RE: Turkey Point Units 3 and 4  
Docket Nos. 50-250 and 50-251  
Homestead AFB Property Disposal

We understand that the Nuclear Regulatory Commission ("NRC") is completing a Safety Evaluation Report ("SER"), for the Final Supplemental Environmental Impact Statement. Sierra Club, Miami Group, has notice that a significant amount of important information seems to be missing from the public record including the Draft Supplemental Environmental Impact Statement ("DSEIS"). We respectfully request that you ensure that the information below is incorporated into the calculations and conclusions of the SER.

FIG  
AERIAL PHOTO

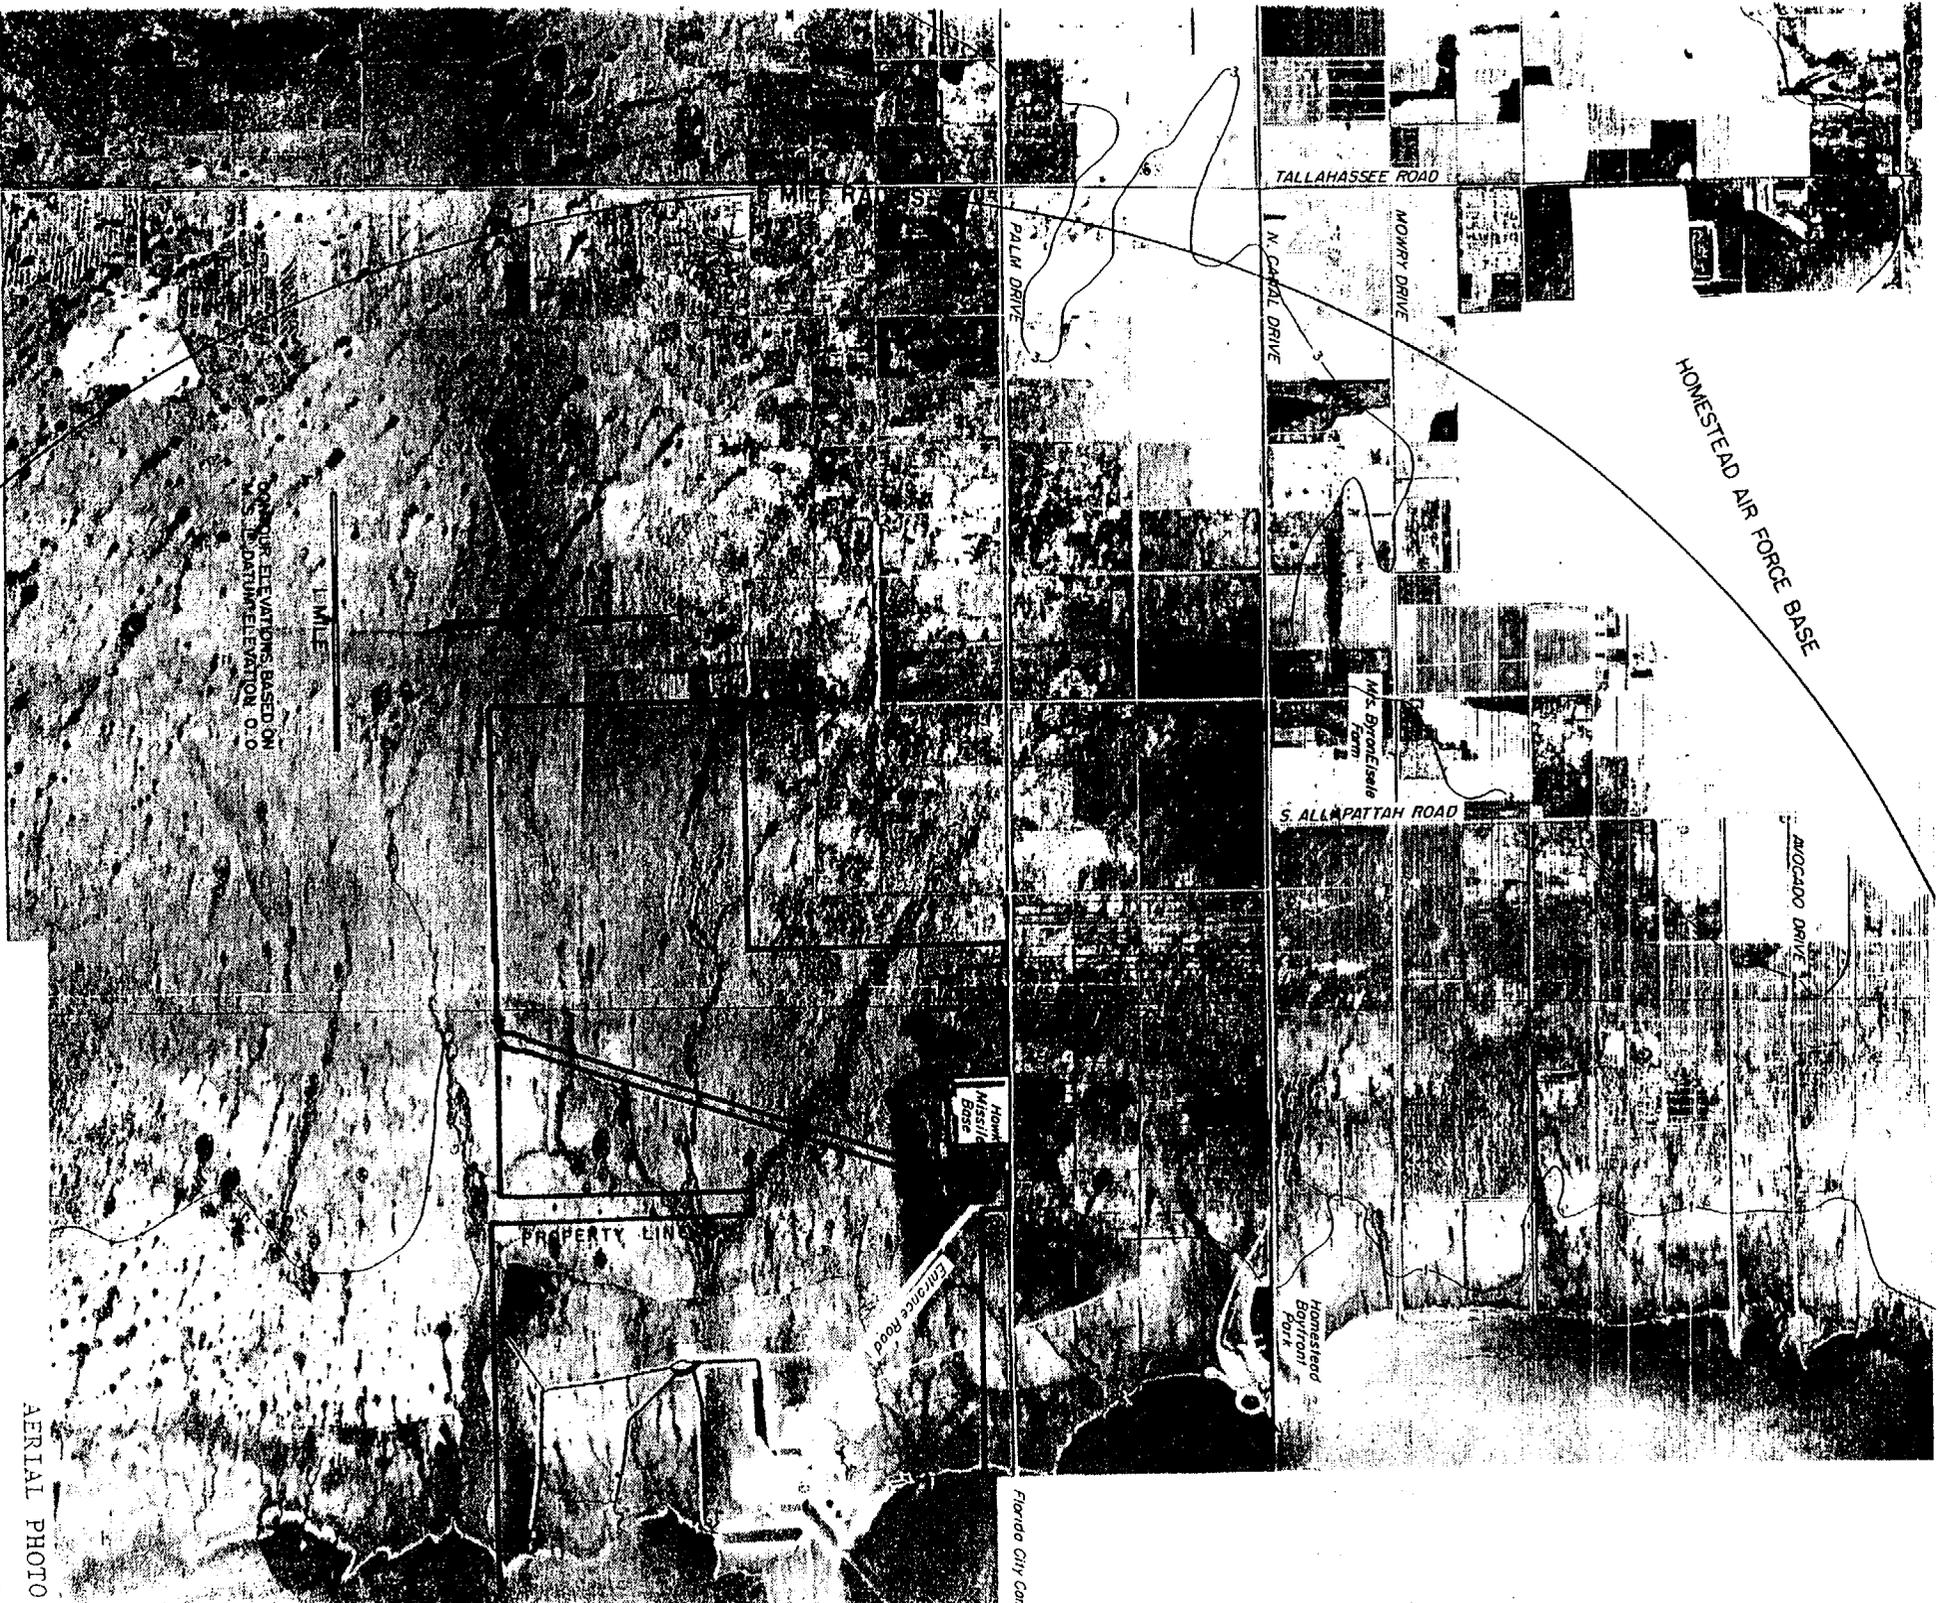
4. In the Turkey Point Final Safety Analysis Report (ref. 6, fig. 2.2-2, fig. 2.5-1, fig. 2.5-2), the relevant aerial photograph, maps, and diagrams appear to show that portions of Homestead Air Force Base lie within a 5 mile radius of the plant. How does this meet acceptance criteria II.1.a and II.1.b of NUREG-0800 (ref. 3, p 3.5.1.6-2) ?
